Subject: East Altamont Energy Center Application for Certification
Data Request Response Set #1 (01-AFC-04)

East Altamont Energy Center
Data Requests and Responses (01-AFC-4)
Set #1

EAST ALTAMONT ENERGY CENTER DATA REQUEST AND RESPONSE SET #1 (01-AFC-4)

Technical Area: Visual Resources

Figure Vis 3-10
View from KOP 1. The Tracy Substation is the illuminated facility visible on the right.

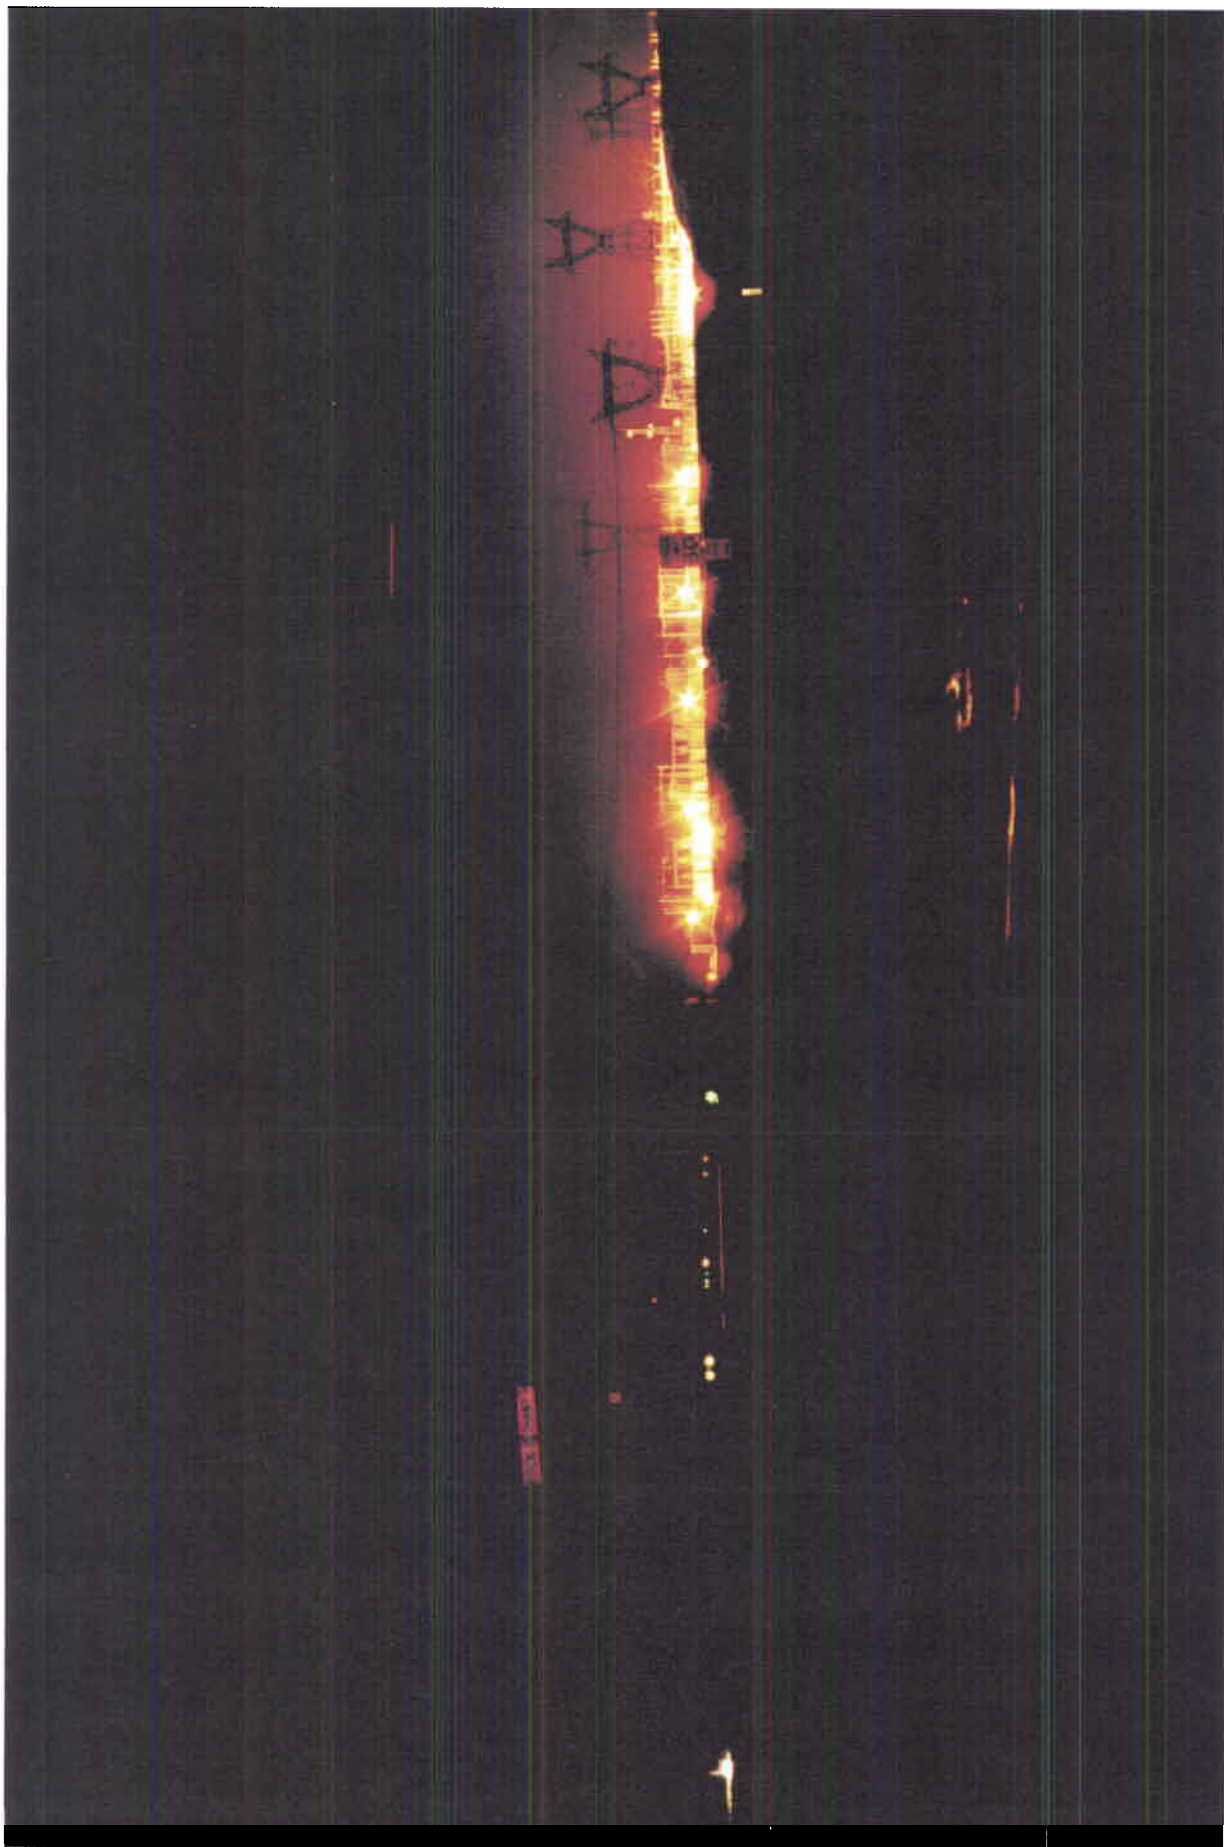
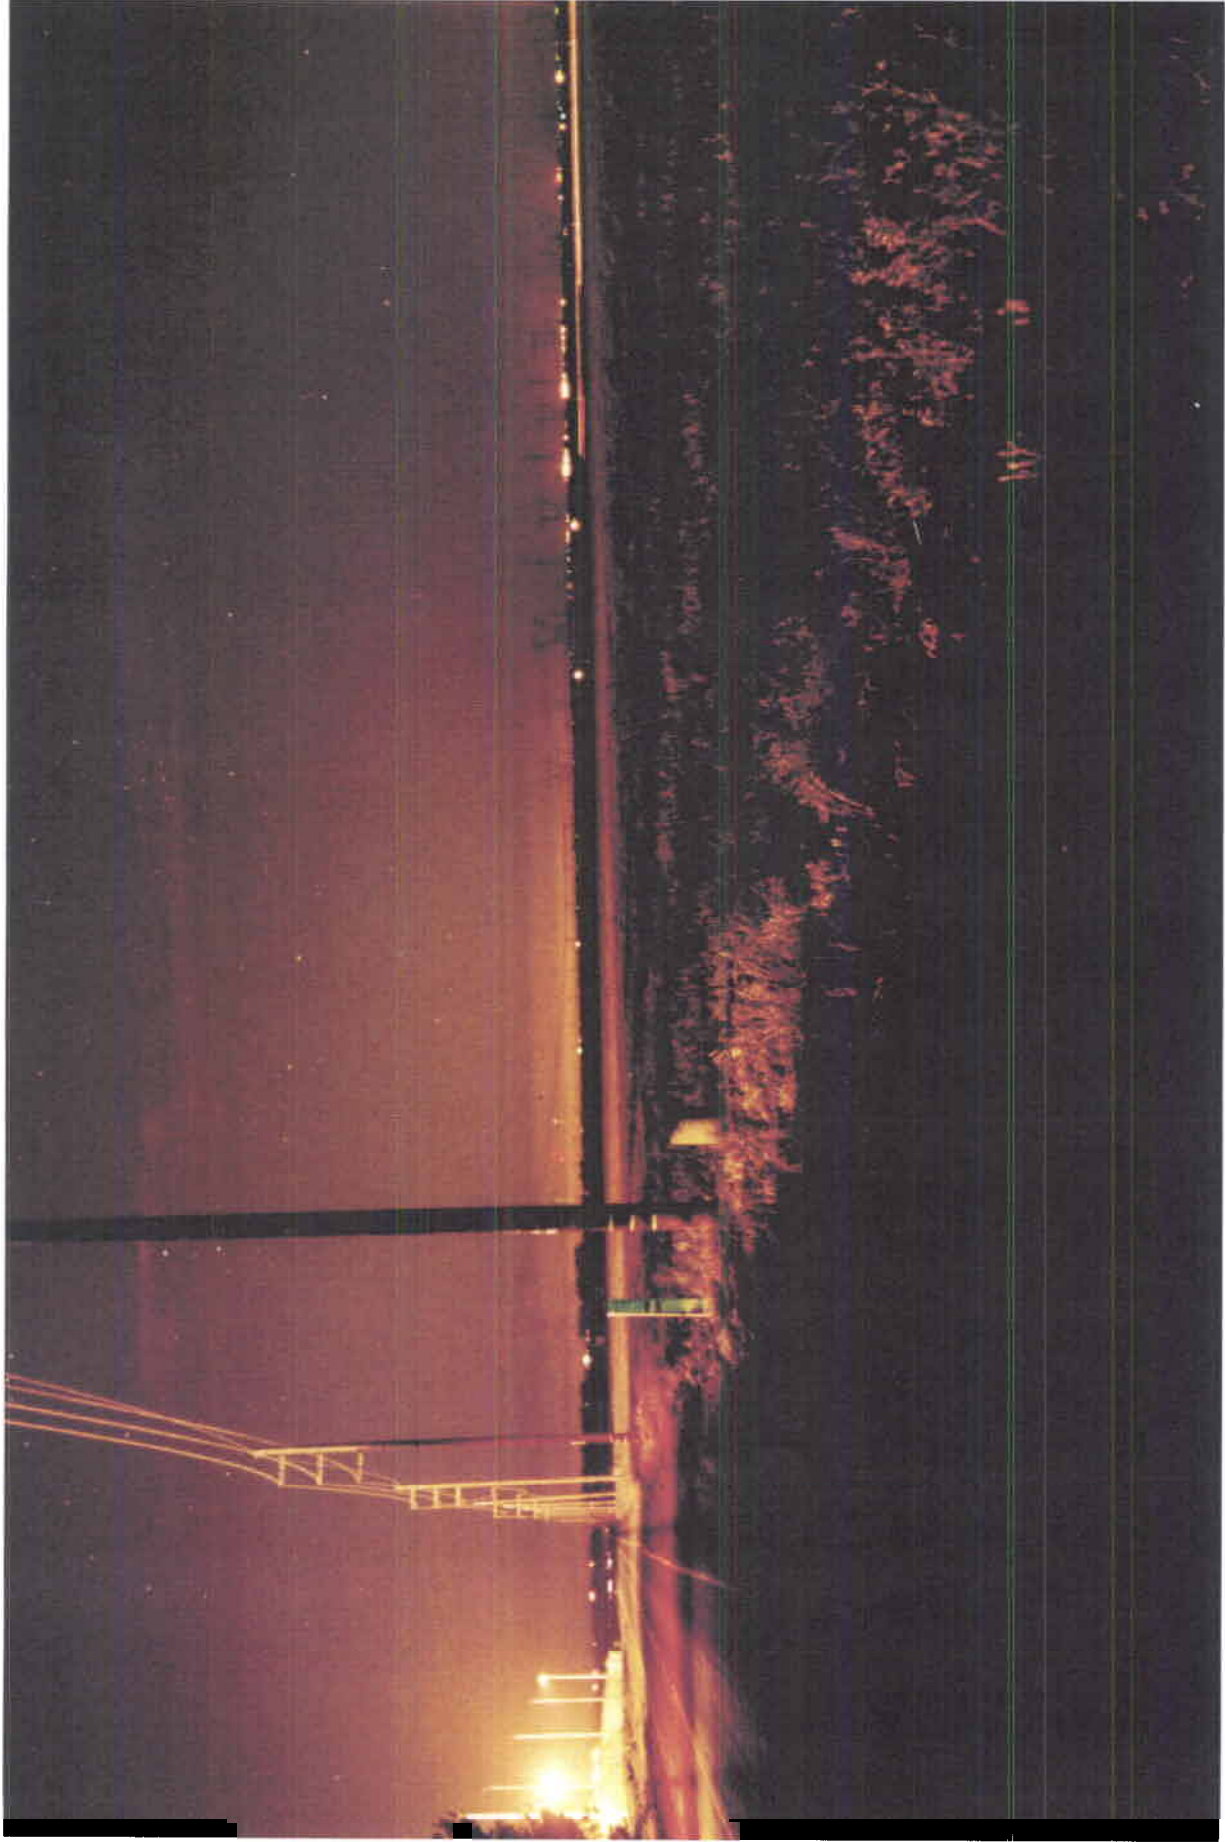
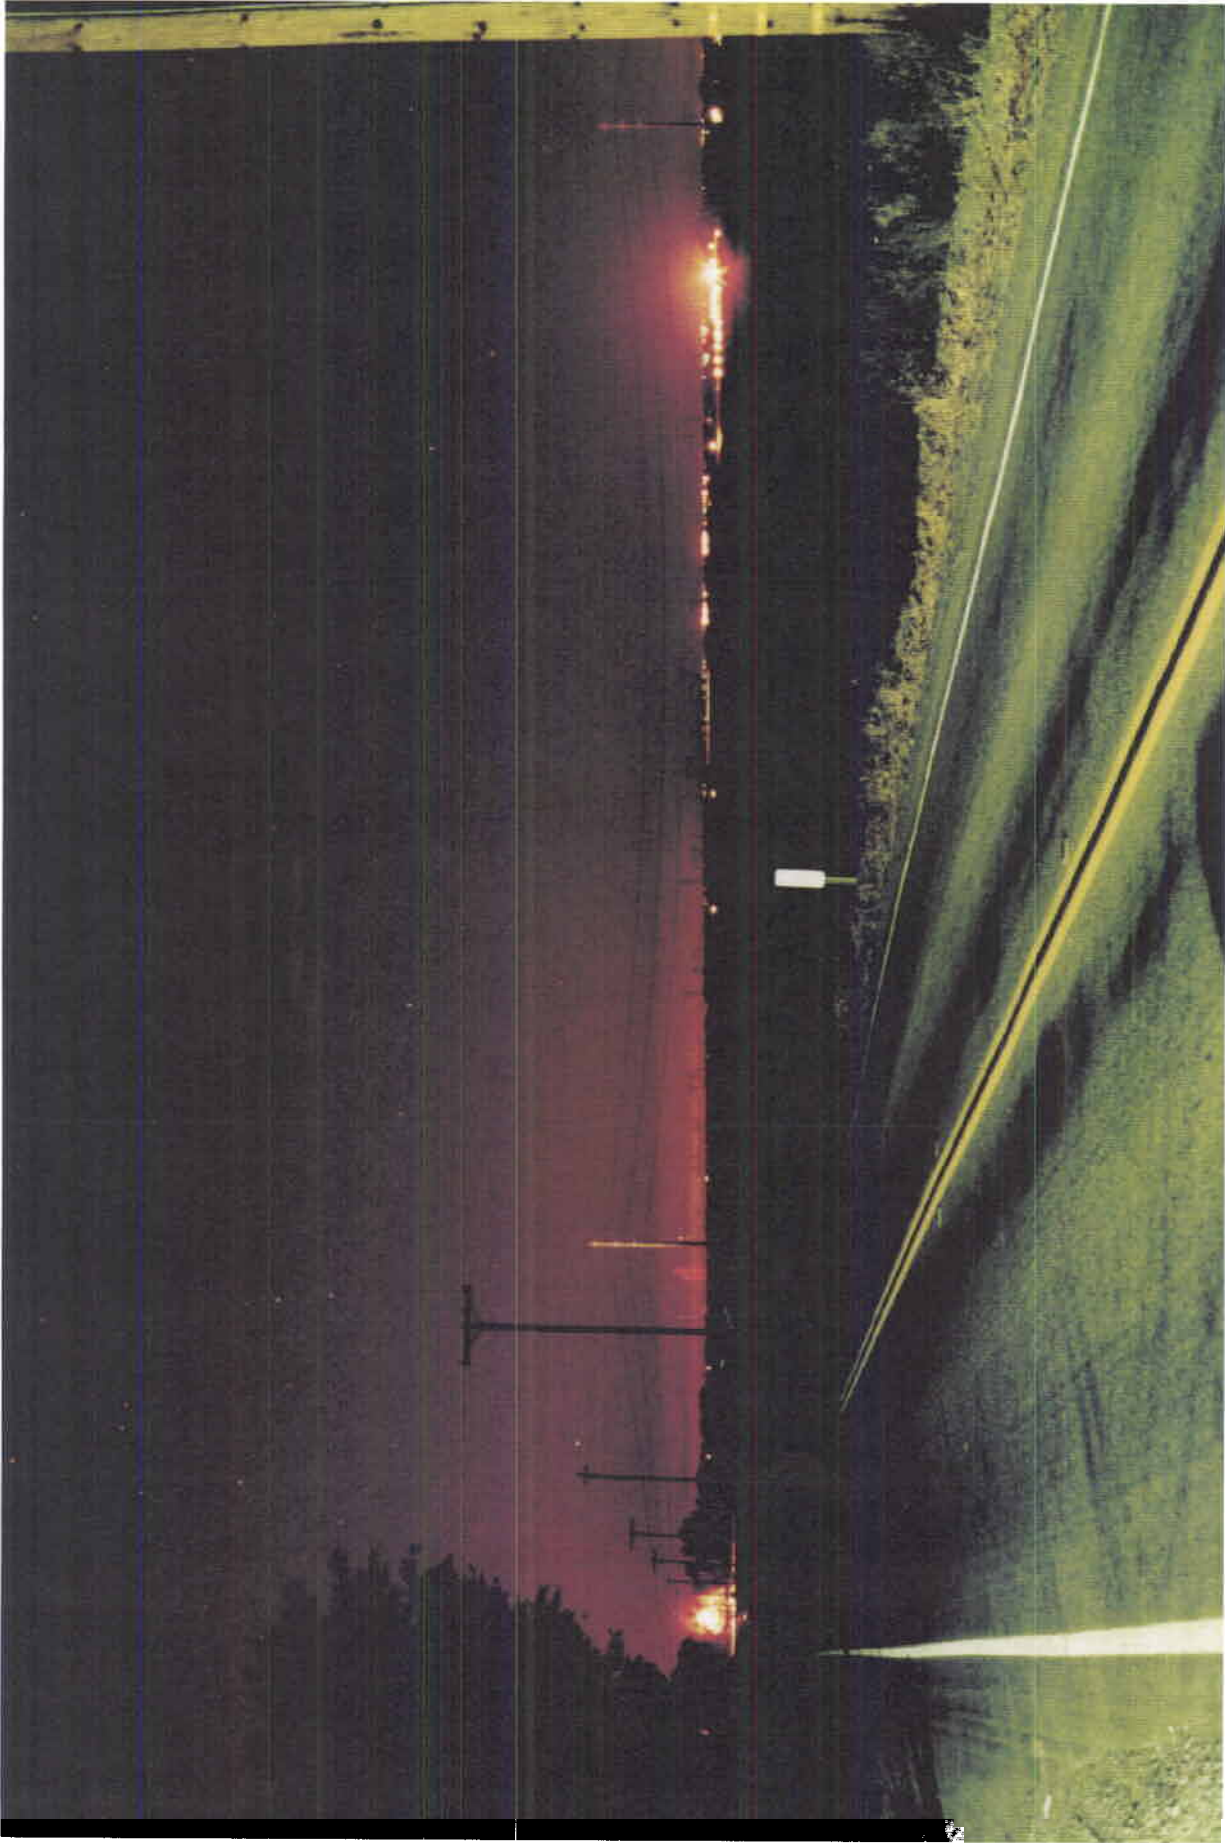
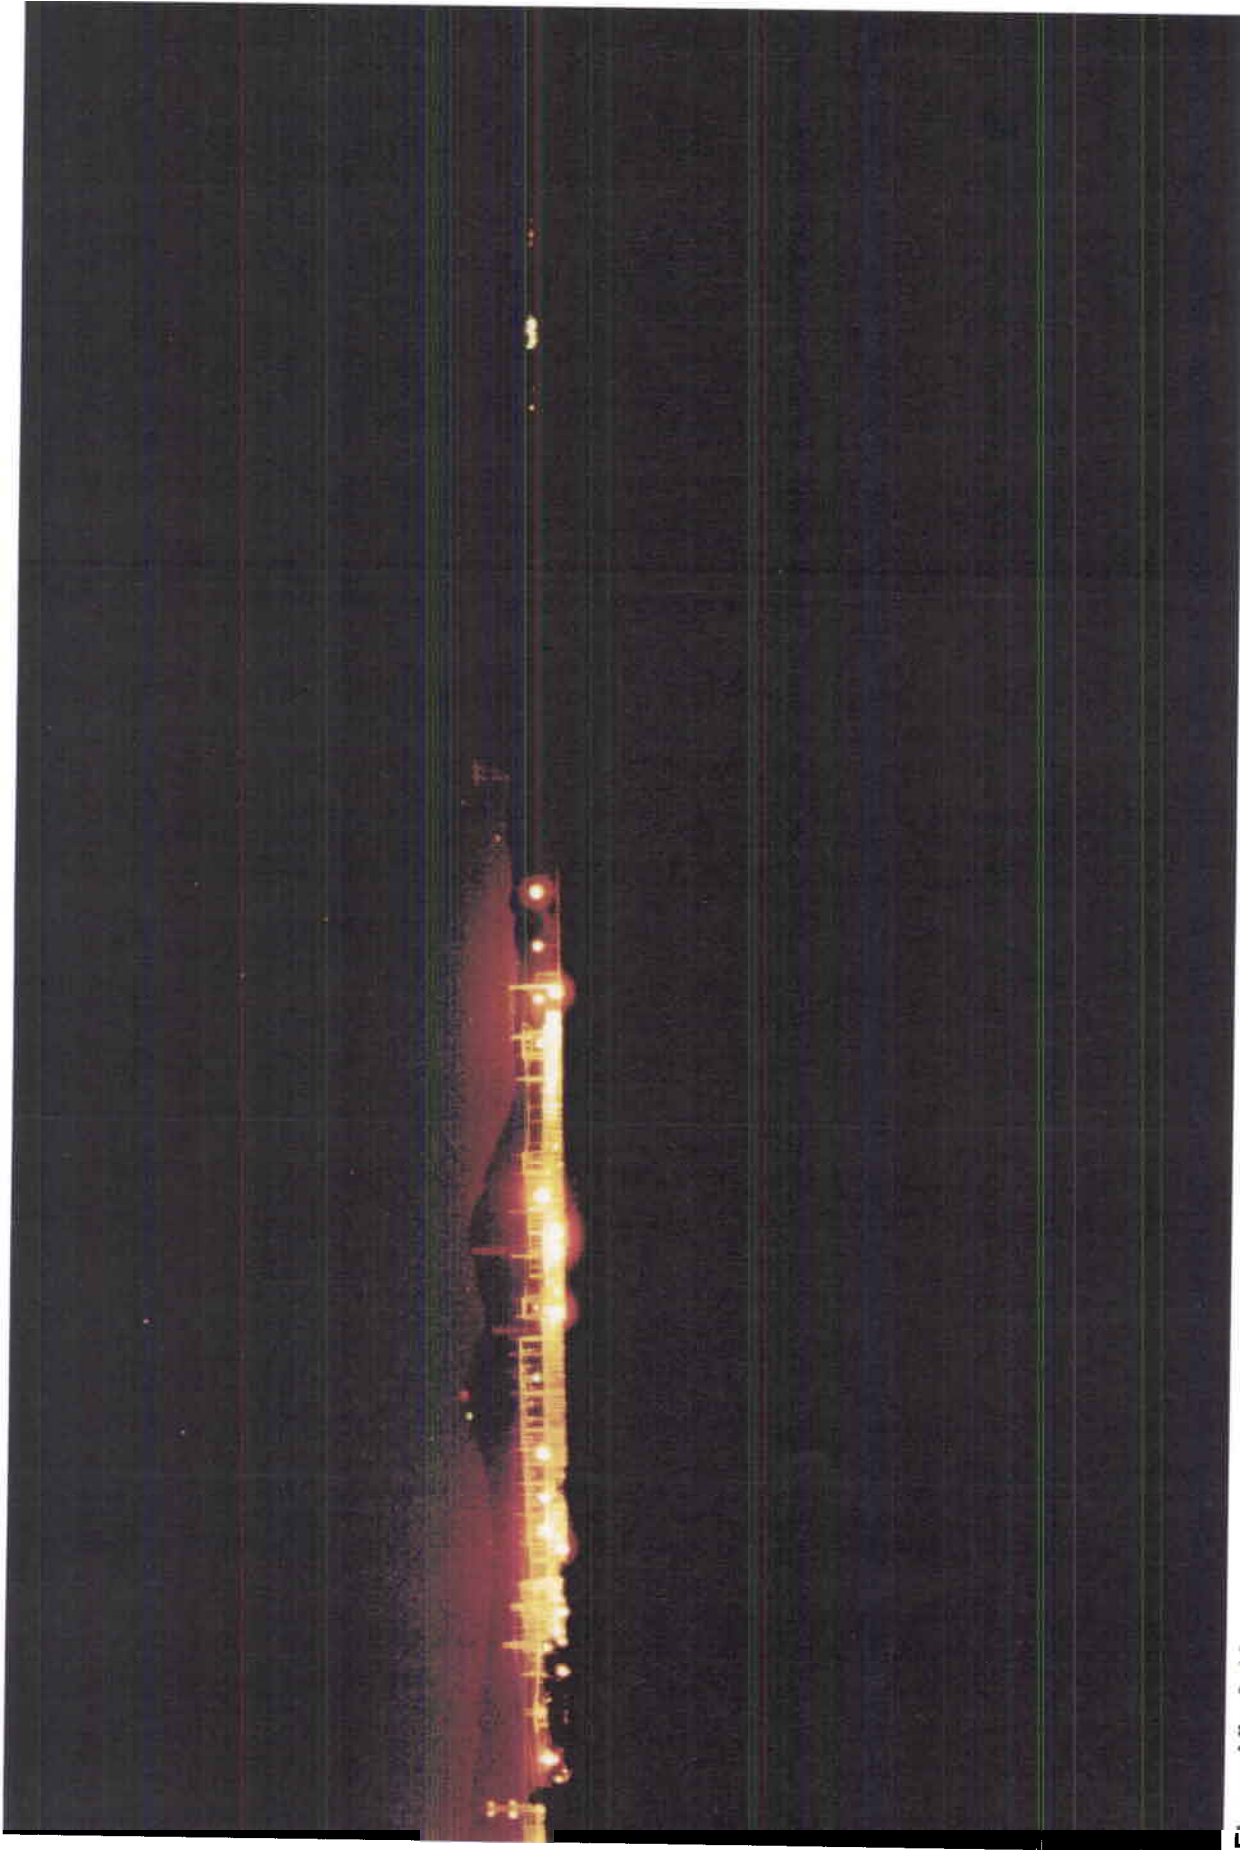
- 3. Please provide five sets of high-resolution color photocopies, at life-size scale when viewed from a distance of 18 inches, of a photograph of the existing view toward the proposed power plant site from KOP 5 at night.

Response: Attached is a sets of high-resolution color photocopies, at 11 x 17, of a photograph of the existing view toward the proposed power plant site from KOP 5 at night.

As a further response to this data request, we are also submitting the following documentation of the night lighting conditions that now exist in the vicinity of the project site.

The Western Area Power Administration's Tracy Substation is located across Mountain House Road, immediately to the southeast of the EEAC site. The equipment in this large facility is brightly lit at nighttime. Figure Vis 3-2 is a night view of the 500 kV switchyard as seen from the east. Because there is no landscaping or solid fencing around this portion of the substation, the brightly illuminated equipment is fully visible, and light from the substation extends into the surrounding landscape. Figure Vis 3-3 is a view of the 230 kV substation, seen from Kelso Road. Although the tree hedge along Kelso Road reduces the visibility of the highly illuminated equipment from the surrounding area to some extent, there are places like the one visible in the photo where there is no landscaping, and the brightly lit equipment is readily visible.

Figure Vis 3-4 is a view of the Central Valley Project's Tracy O&M Complex, which is located adjacent to Tracy Pumping Plant. This complex is located approximately 0.6 miles southeast of the EAEC project site. The complex's parking lot lights and illuminated building facades are visible from Kelso Road and from the cluster of rural residences that lie across the street from it.

Figure Vis 3-5 is a view from Kelso Road looking west toward the PG&E gas compressor station. This compressor station lies approximately 1.3 miles to the southeast of the project site. As this photo indicates, the structures and yard are brightly lit, and cast ambient light into the surrounding area.

Figure Vis 3-6 is a view of the Department of Water Resources' Banks Pumping Plant, which is located at the base of the hills 2.4 miles to the west of the project site. As this photo suggests, the substation and buildings at the pumping plant complex are brightly lit, and cast a glow into the sky.

Figure Vis 3-7 is a view of the Department of Water Resources' Skinner fish screening facility located at the California Aqueduct's intake at Clifton Court Forebay. This facility is located 1.3 miles north of the project site and is highly visible from the nearby Byron Highway. As the photo indicates, the structures and outdoor areas at the Skinner Facility are brightly lit, and the lighting casts a glow that extends into the surrounding area.

Night lighting in the project area is not restricted to the major infrastructure facilities. Frequent use of outdoor security lights is made at individual farm and residential properties as well. In addition, Mountain House School, which is located on Mountain House Road approximately 0.8 mile south of the project site is brightly lit at night by a porch light and a pole-mounted security light (Figure Vis 3-8).

set of extremely bright temporary floodlights has been installed (Figure Vis 3-9). These floodlights cast a pronounced glow into the sky, and can be seen for miles around.

Figure Vis 3-10 is the nighttime view from KOP 1. The brightly illuminated 500 kV switchyard at the Tracy Substation, which is located across Mountain House Road and to the immediate southeast of the project site is visible in the right half of the photo. Figure Vis 3-11 is the view from KOP 2. The Tracy Substation's 500 kV yard is visible at the left edge of the view, on the west side of Mountain House Road. As the photo indicates, the substation casts a glow that illuminates the transmission lines along the eastern edge of the road, and even illuminates a portion of the surface of the project site.

Figure Vis 3-12 is the view from KOP 3, the viewpoint located on Mountain House Road directly in front of Mountain House School. In this photo, stray light from the security lighting at the school (see Figure Vis 3-8) illuminates the roadway in the immediate foreground of the view. Light from the Tracy Substation is visible in the distance in the middle of Mountain House Road. The glow from the substation is so bright that it illuminates the steel pole transmission tower located on Kelso Road just to the east of Mountain House Road.

Figure Vis 3-13 is the view from KOP 4, the viewpoint located in front of a residence on Kelso Road at a point half way between Mountain House and Byron-Bethany Roads. In this view, the brightly illuminated equipment at the Tracy Substation is readily visible, as is the glow that the substation casts into the sky. The cluster of bright lights in the distance at the right side of the view may be from DWR's Skinner Facility.

Figure Vis 3-14 is the view from KOP 5, the viewpoint located at Lindeman Road's intersection with Byron Bethany Road. The brightly lit equipment at the Tracy Substation is highly visible in the center of the view. The bright construction floodlighting at Bethany Reservoir is visible in the distance on the view's left edge. The lighting from the substation and reservoir construction site combine to create a large area of glowing sky.

Figure Vis 3-15 is the view from KOP 6, the viewpoint established on Kelso Road 0.45 mile east of Mountain House Road to document the changes associated with the project's transmission line. At night, this view is dominated by the brightly lit equipment at the Tracy Substation, and by the glow it casts into the sky above.
